PCI-SIG ENGINEERING CHANGE NOTICE

TITLE:	L1 PM Substates with CLKREQ, Revision 1.0a
DATE:	Last Modified 15 Aug 2012 31 May 2013 ; Protocol Workgroup Final Approval: 23 Aug 2012 Errata for Rev 1.0a PWG approved 30 May 2013
AFFECTED DOCUMENTS:	PCI Express Base Specification Revision 3.0, PCI Express Base Specification Revision 2.1, PCI Express Mini Card Electromechanical Specification Revision 1.2, PCI Express Card Electromechanical Specification Revision 2.0, 8.0 GT/s Receiver Impedance ECN
SPONSOR:	Intel Corporation, Hewlett-Packard Company

Figure 5-x1: State Diagram for L1 PM Substates

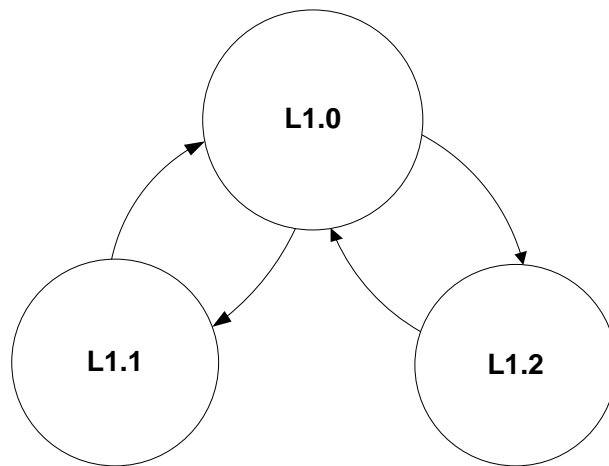
L1 PM Substates establish a Link power management regime that creates lower power substates of the L1 Link state (see **Figure 5-x1**), and associated mechanisms for using those substates. The L1 PM Substates are:

Figure 5-x2: Downstream Port with a Single PLL

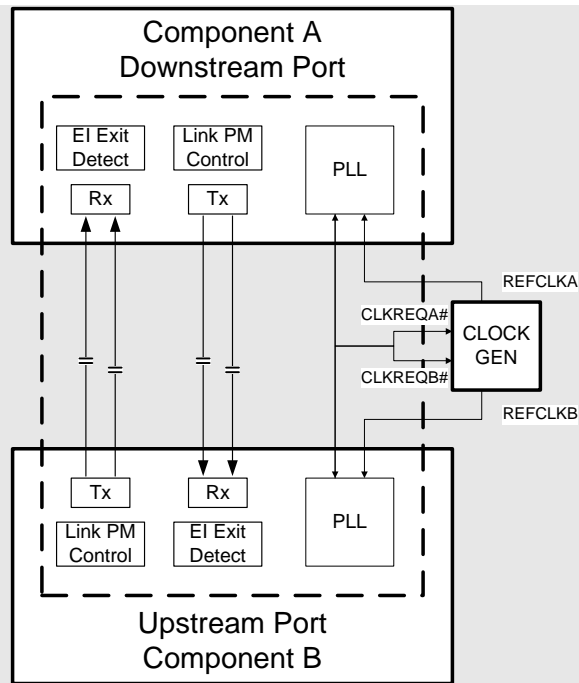
Example 1: Single Downstream Port with a single PLL connected to a single Upstream Port (see Figure 5-x2).

In this platform configuration the Upstream component (A) has only a single CLKREQ# signal. The Upstream and Downstream Ports' CLKREQ# (A and B) signals are connected to each other. In this case, Upstream component (A), must assert CLKREQ# signal whenever it requires a reference clock.

Figure 5-x3: Multiple Downstream Ports with a shared PLL

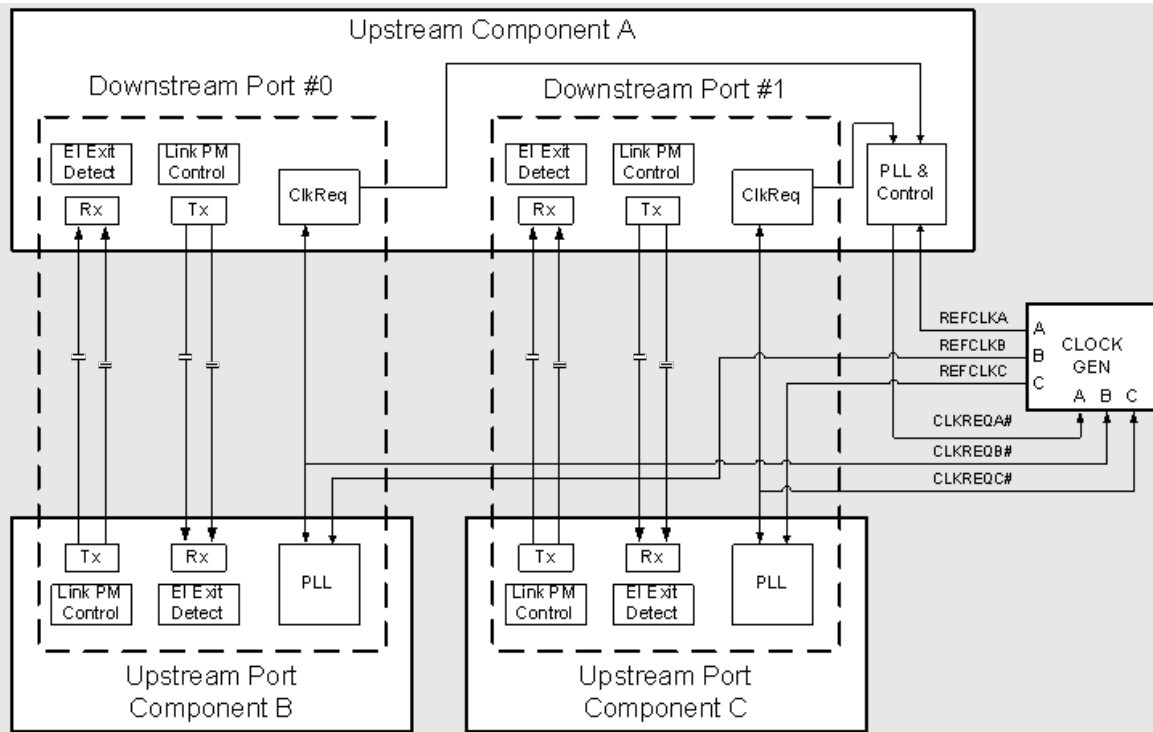
Example 2: Upstream component with multiple Downstream Ports, with a common shared PLL, connected to separate Downstream components (see Figure 5-x3).

In this example configuration, there are three instances of CLKREQ# signal for the Upstream component (A), one per Downstream Port and a common shared CLKREQ# signal for the Upstream component (A). In this topology the Downstream Port CLKREQ# (CLKREQB#, CLKREQC#) signals are used to connect to the CLKREQ# signal of the Upstream Port of the Downstream components (B and C). The common shared CLKREQ# (CLKREQA#) signal for the Upstream component is used to request the reference clock for the shared PLL. The PLL control logic in Upstream component (A) can only be turned off and CLKREQA# be de-asserted when both the Downstream Ports are in L1.1 or L1.2 Substates, and all internal (A) consumers of the PLL don't require a clock.

Figure 5-x4: Example: L1.1 Waveforms Illustrating Upstream Port Initiated Exit

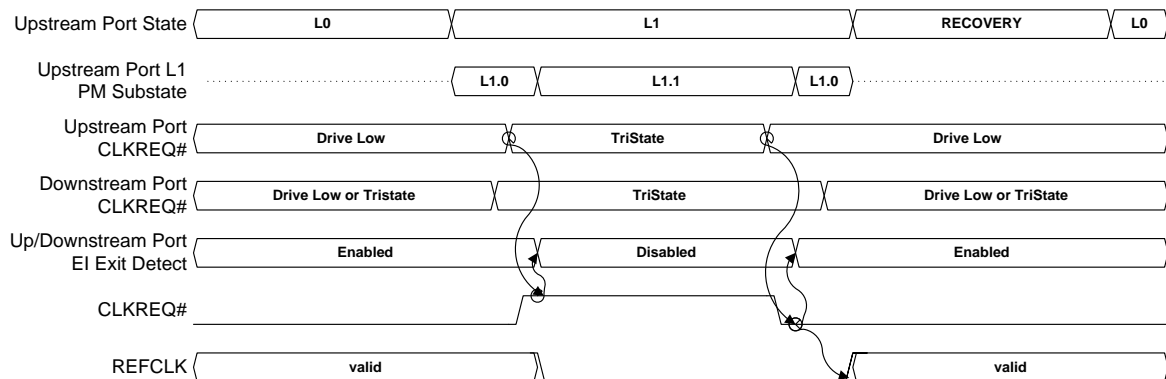
Figure 5-x4 illustrates entry into L1.1 with exit driven by the Upstream Port.

Figure 5-x5: Example: L1.1 Waveforms Illustrating Downstream Port Initiated Exit

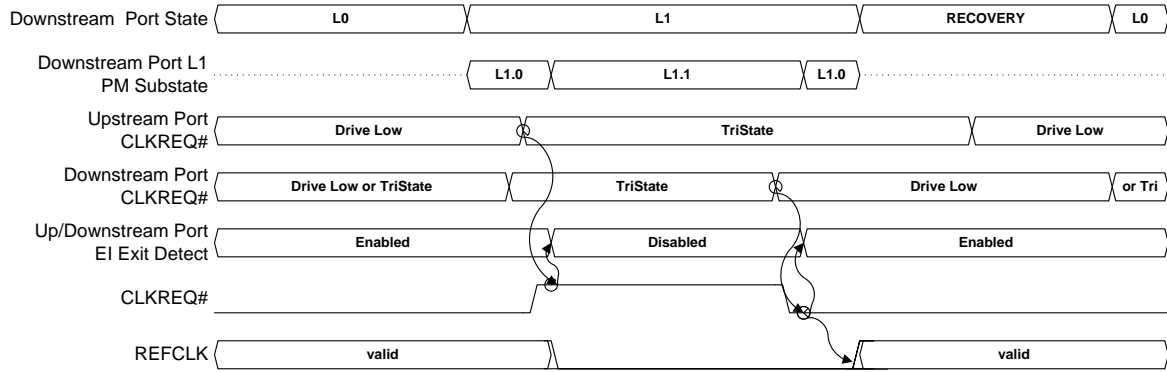
Figure 5-x5 illustrates entry into L1.1 with exit driven by the Downstream Port.

Figure 5-x6: L1.2 Substates

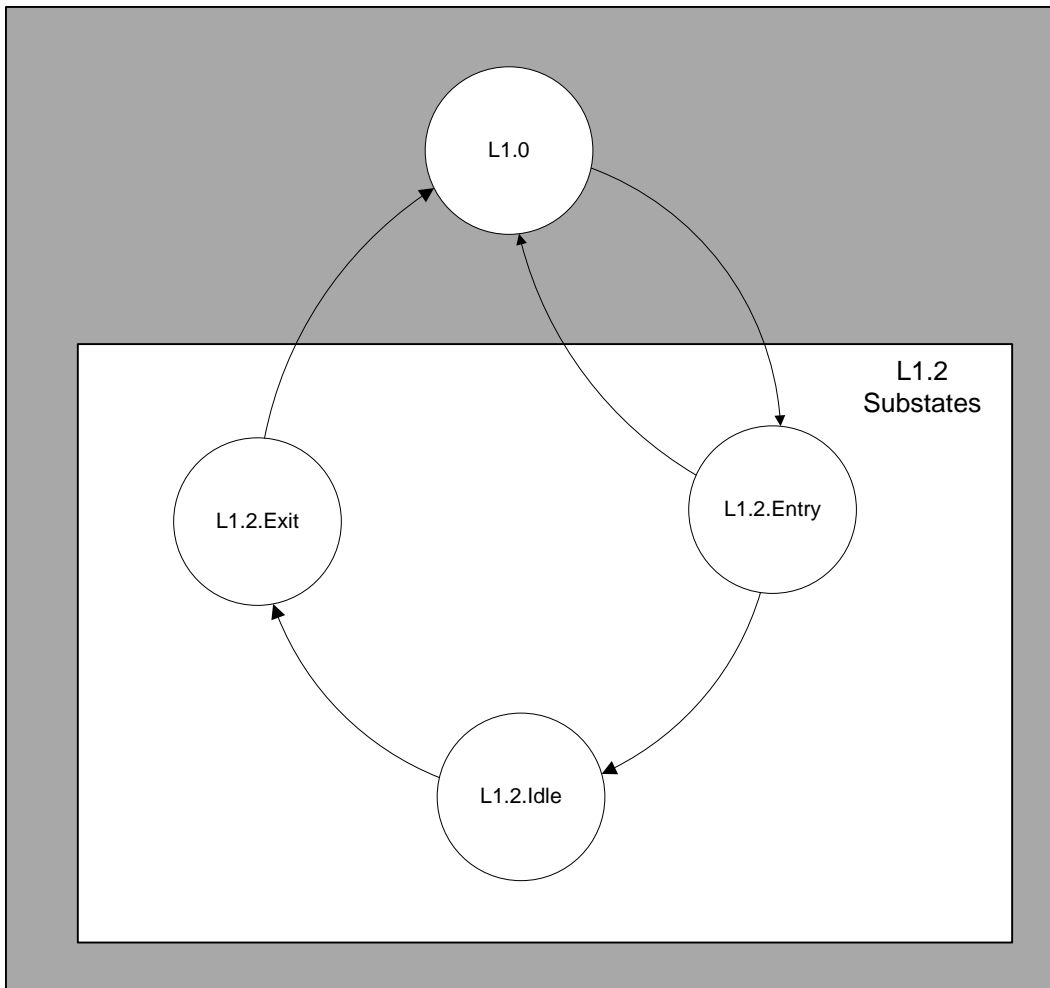
L1.2 has three substates, which are defined below (see Figure 5-x6).

Figure 5-x7: Example: Illustration of Boundary Condition due to Different Sampling of CLKREQ#

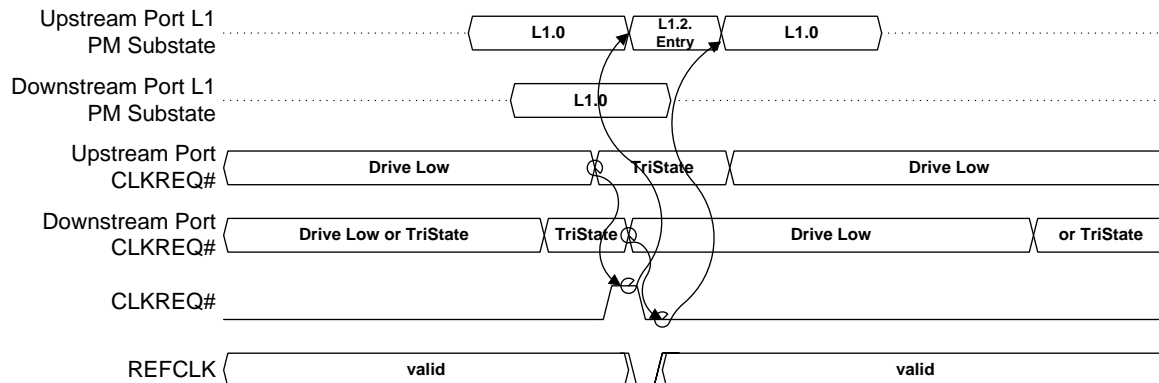
Note that there is a boundary condition which can occur when one Port asserts CLKREQ# shortly after the other Port de-asserts CLKREQ#, but before the first Port has observed

CLKREQ# de-asserted. This is an unavoidable boundary condition that implementations must handle correctly. An example of this condition is illustrated in Figure 5-x7.

Figure 5-x8: Example: L1.2 Waveforms Illustrating Upstream Port Initiated Exit

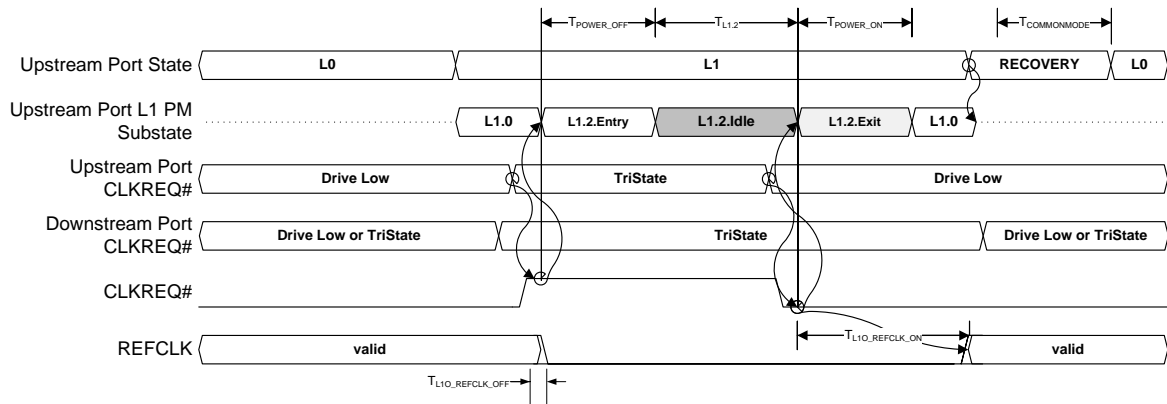
Figure 5-x8 illustrates the signal relationships and timing constraints associated with L1.2 entry and Upstream Port initiated exit.

Figure 5-x9: Example: L1.2 Waveforms Illustrating Downstream Port Initiated Exit

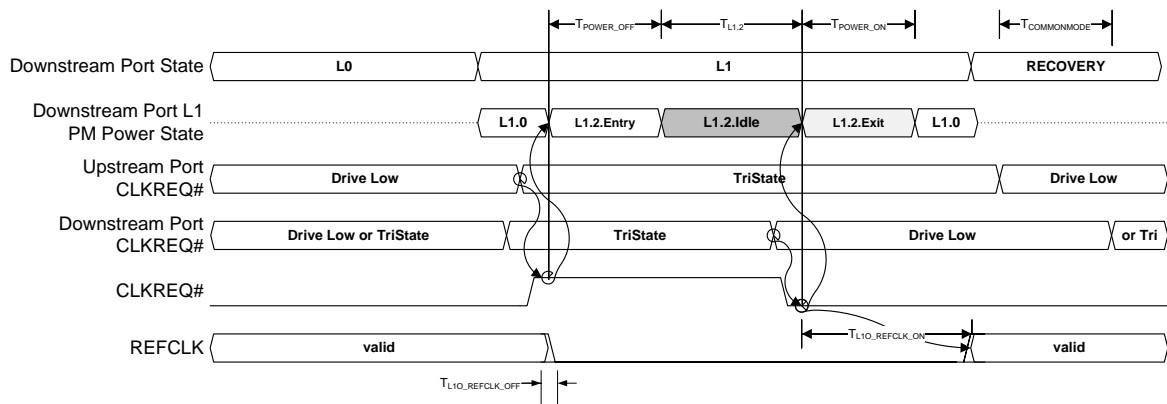
Figure 5-x9 illustrates the signal relationships and timing constraints associated with L1.2 entry and Downstream Port initiated exit.

Figure 7-xx: L1 PM Substates Capability

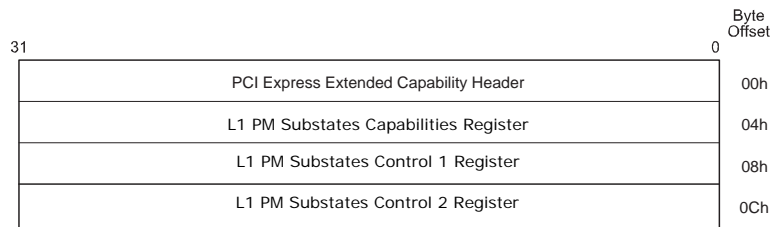
The PCI Express L1 PM Substates Capability is an optional Extended Capability, that is required if L1 PM Substates is implemented at a Port. The L1 PM Substates Extended Capability structure is defined as shown in Figure 7-xx.
